Residences of South Brookline Transportation Peer Review Responses

I. Peer Review (BETA) : Received 3/21/14

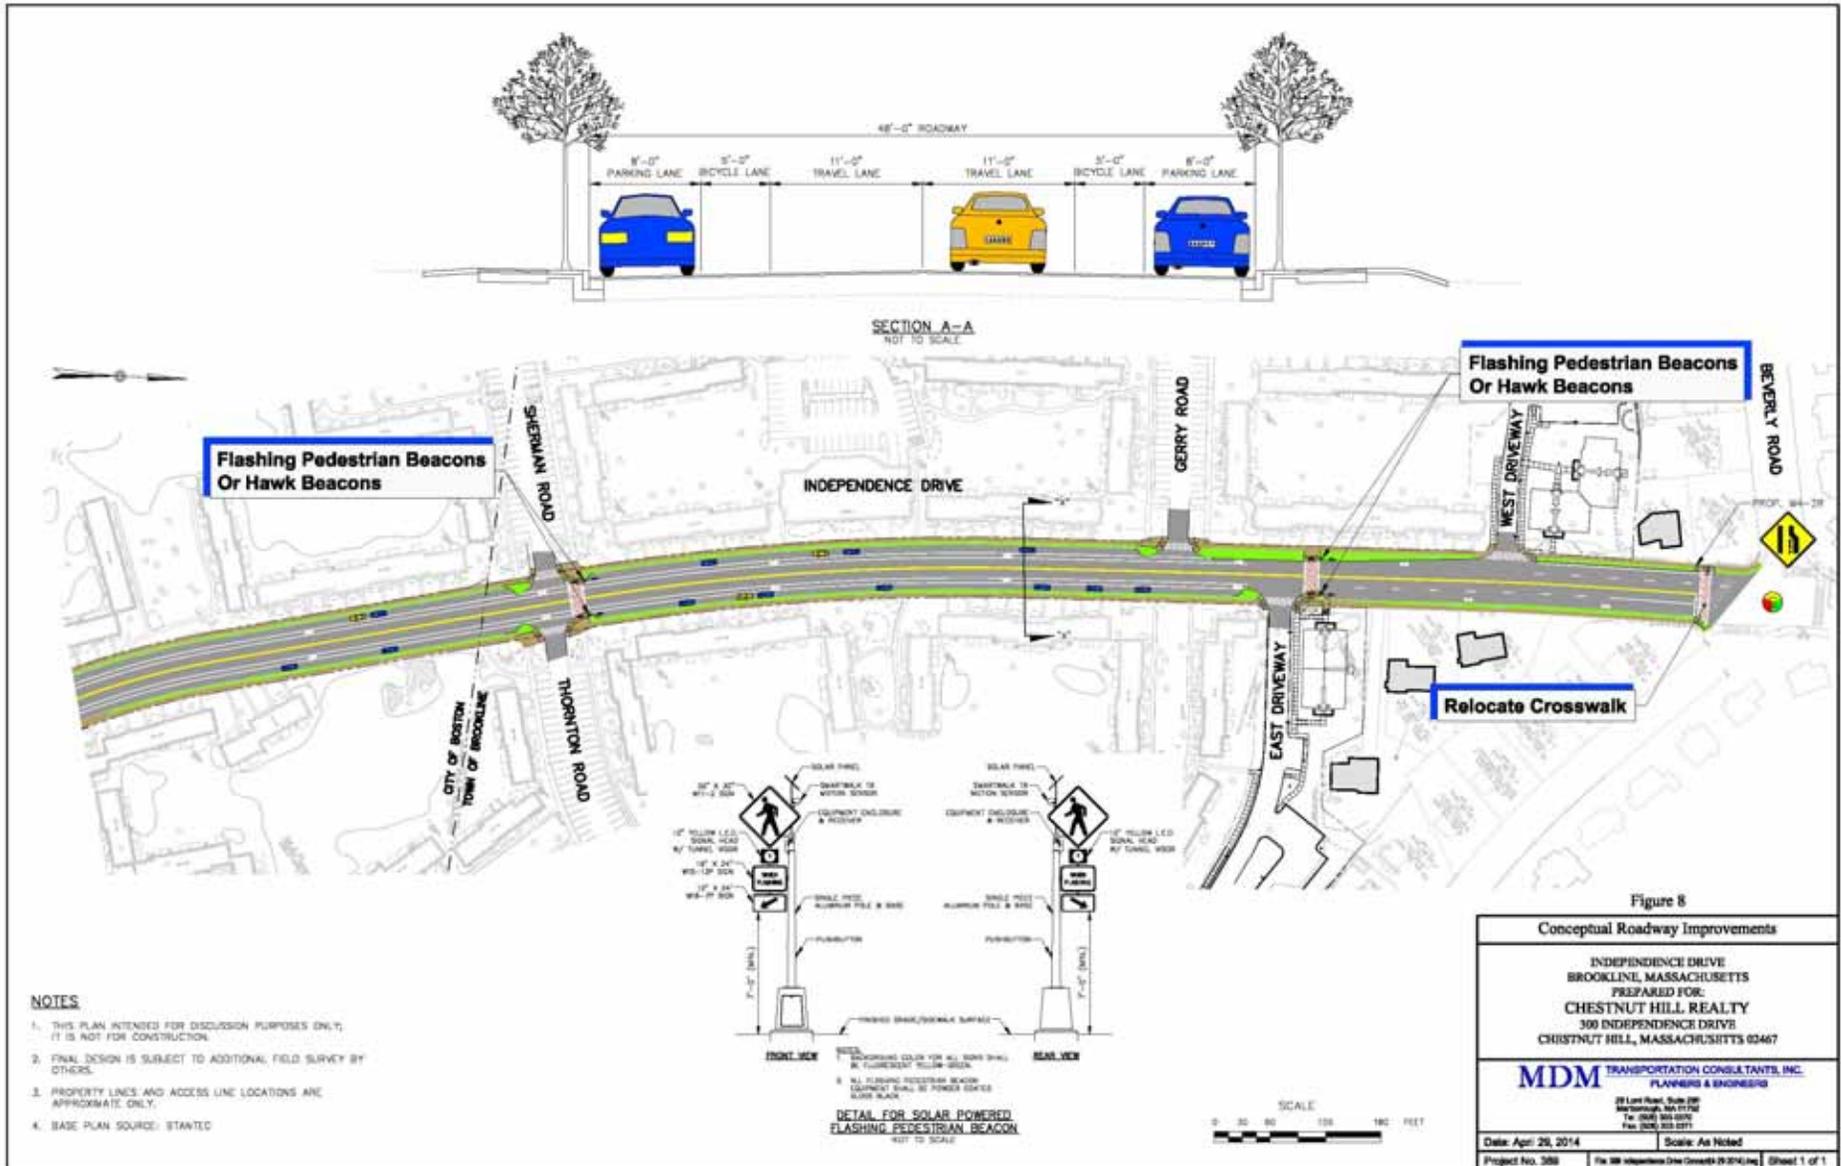
#13 – Russett Road/Asheville Road AWSC

- MUTCD volume-based criteria for installation of all-way stop control (AWSC) are **NOT** met under existing or future build-out traffic volume conditions.
- AWSC may be warranted based on additional (non-volume) criteria subject to Town approval.

AutoTurn® Analysis

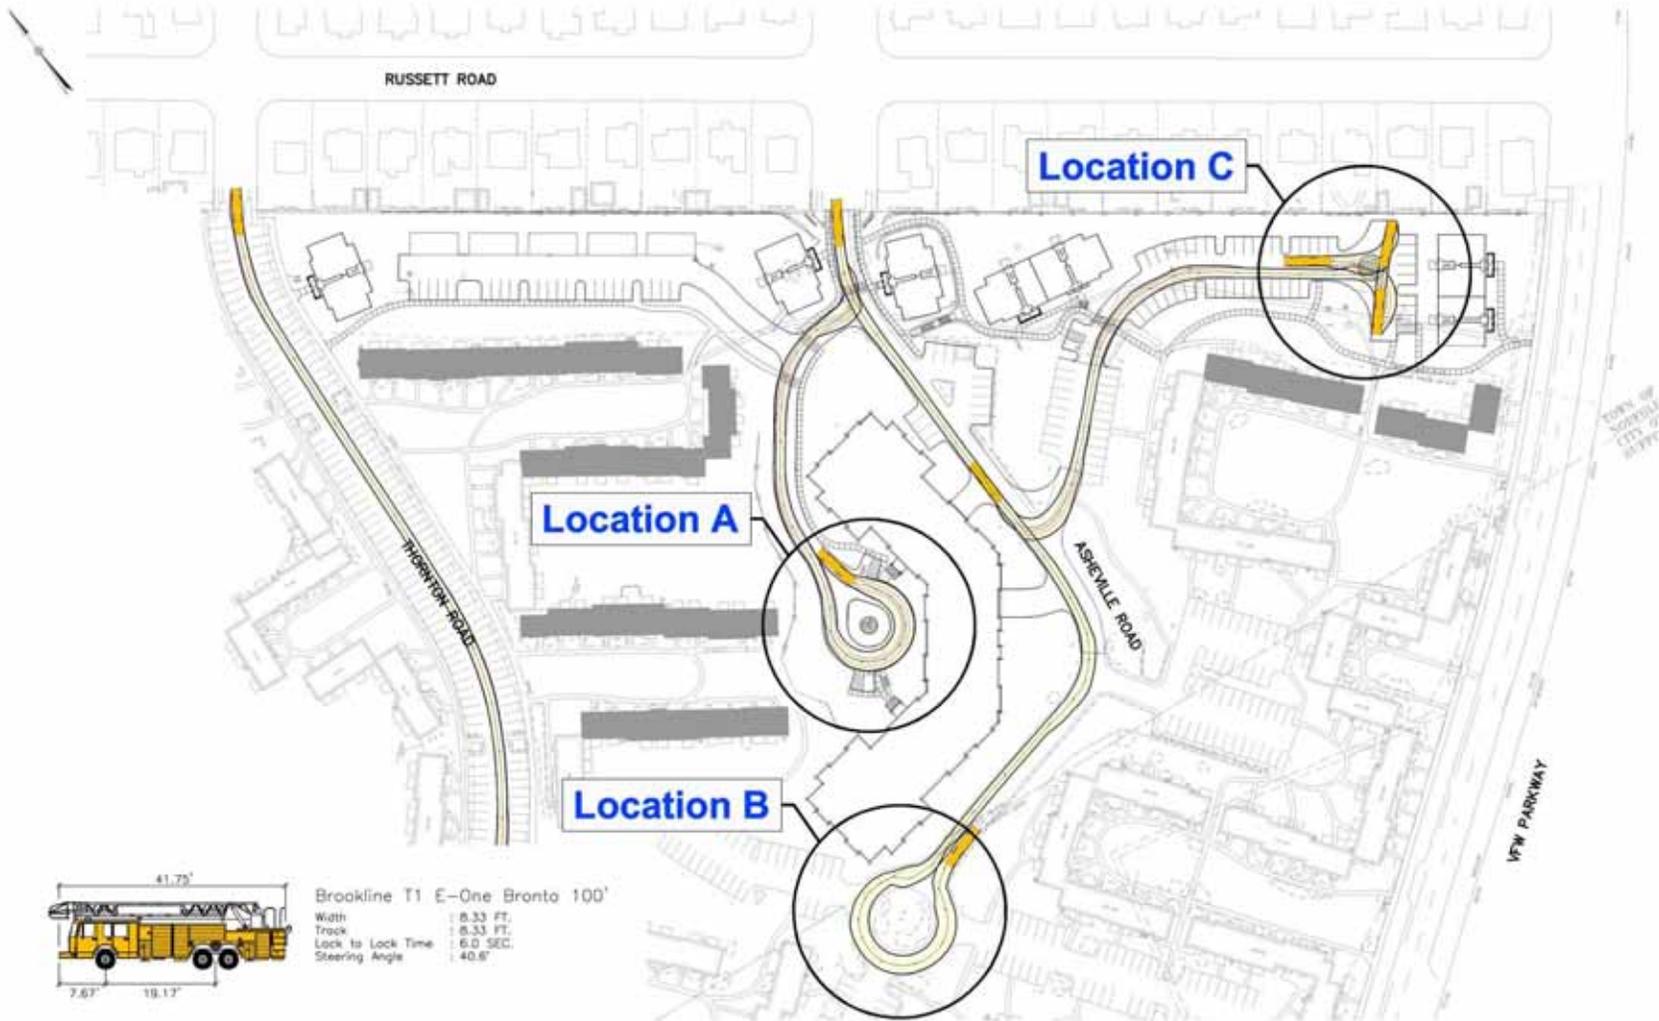
#19 – Emergency Vehicle Circulation

a) AutoTurn® movements for largest apparatus serving the Site

- ❖ Brookline E-One Bronto 100' Tower Truck Modeled
- ❖ Sufficient maneuvering area for multiple trucks with ability to “bypass” one another
- ❖ Consistent design with recently approved Brookline residential projects
- ❖ Consistent design with recently approved residential projects in adjacent communities (Newton and Needham)

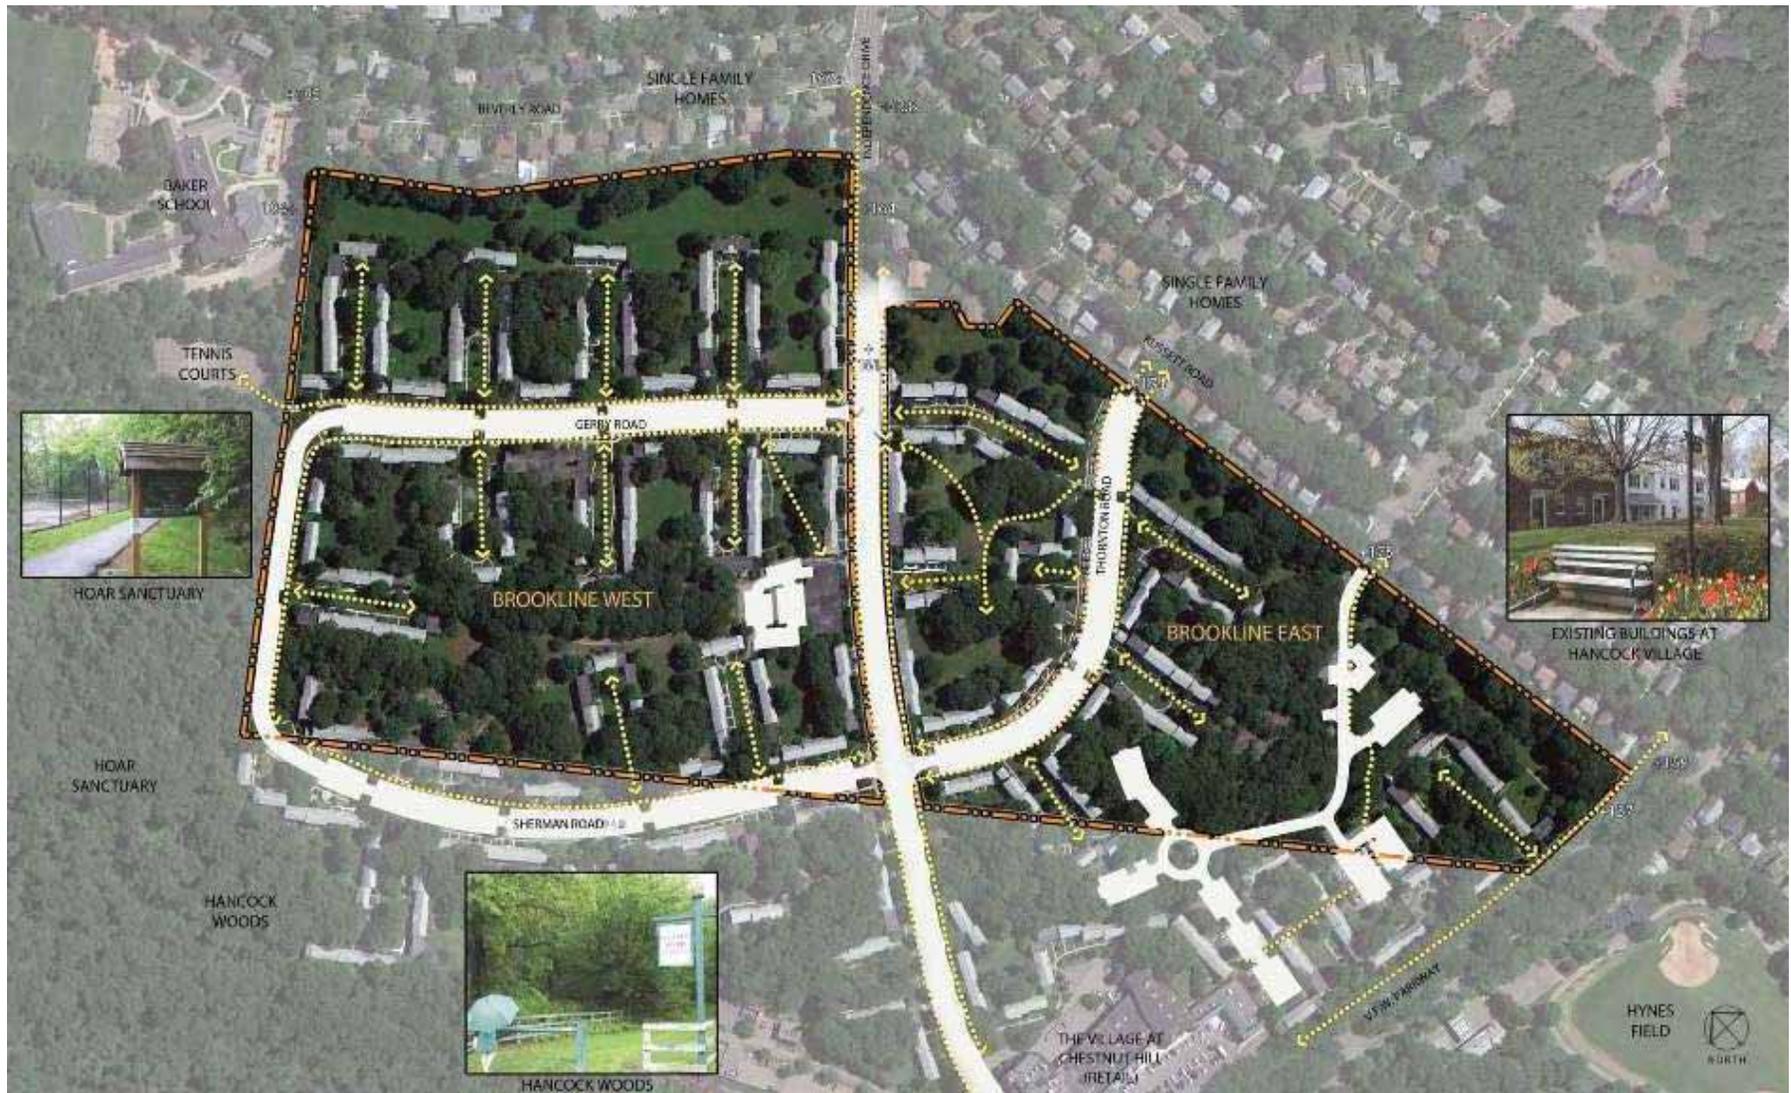
#20 – Fire Trucks in Opposite Directions

- The proposed site roadway width of 22 feet satisfies Brookline zoning requirements and is consistent with roadways that serve Hancock Village.
- Proposed on-site roadways will adequately accommodate emergency vehicles travelling in opposing direction without conflict.

Proposed Pedestrian Access/Site Circulation

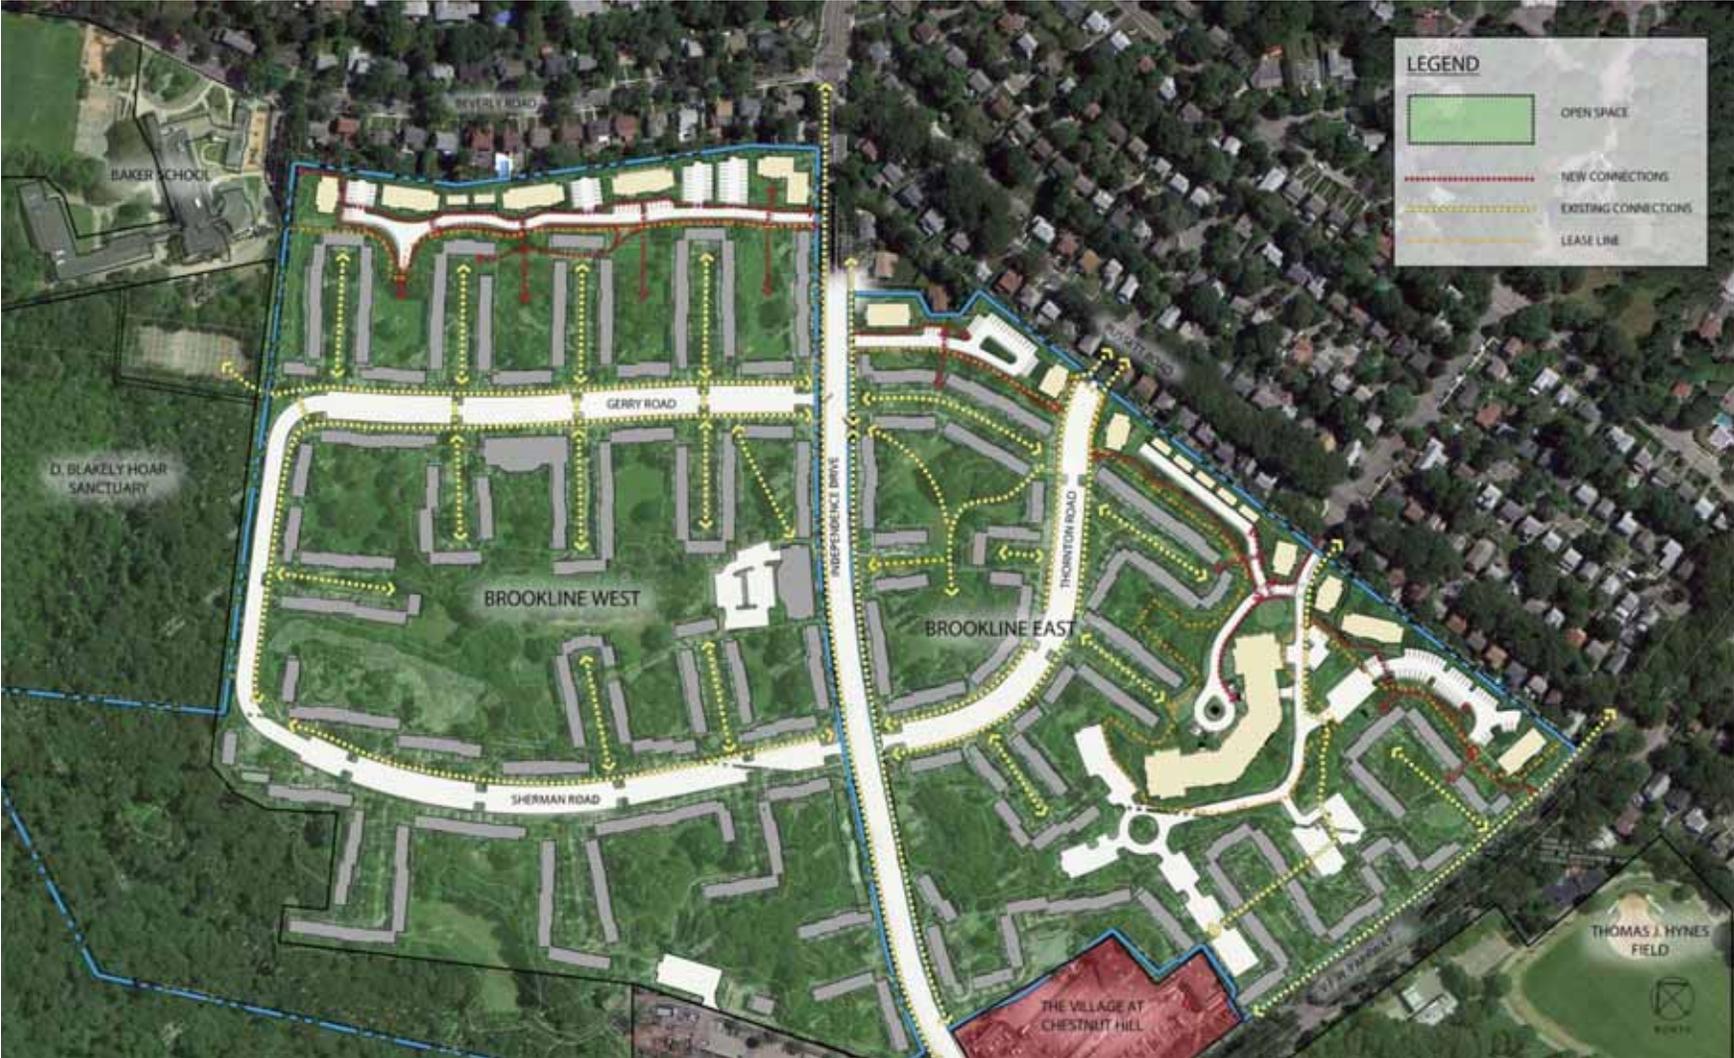
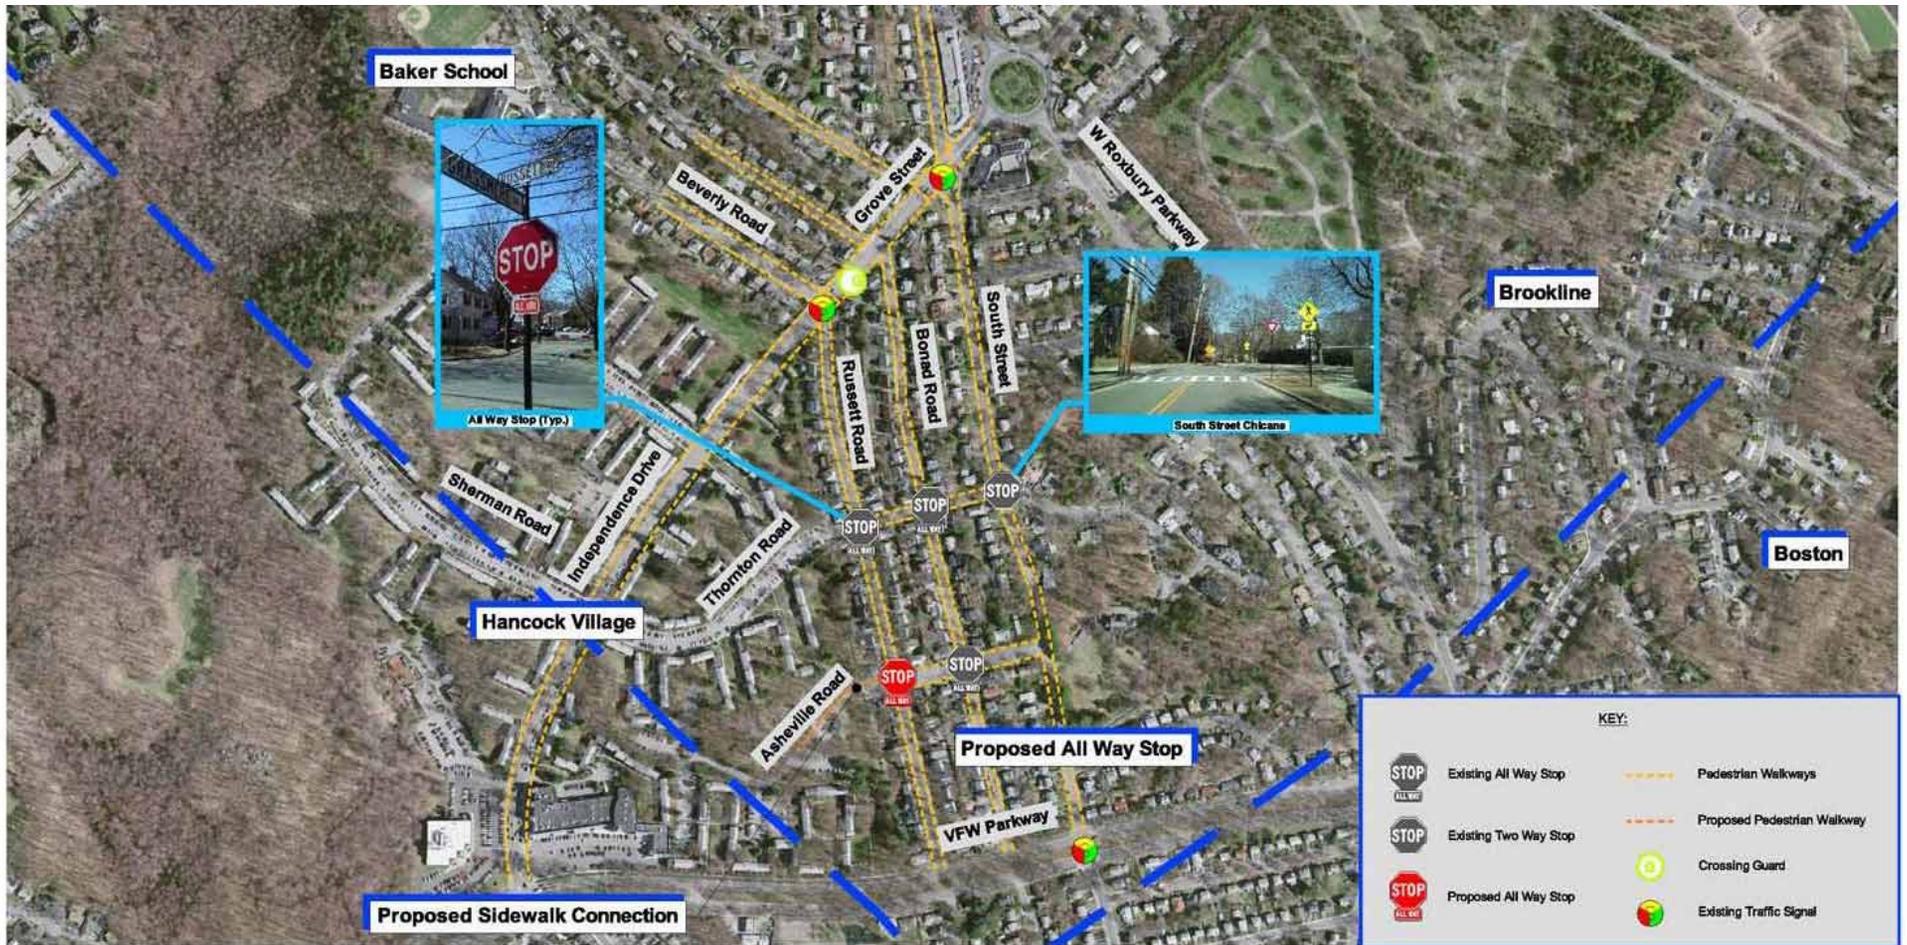
#21 – Pedestrian Safety

- The extensive existing pedestrian system is proposed to be expanded providing adequate and safe access to area amenities (i.e., Baker School).
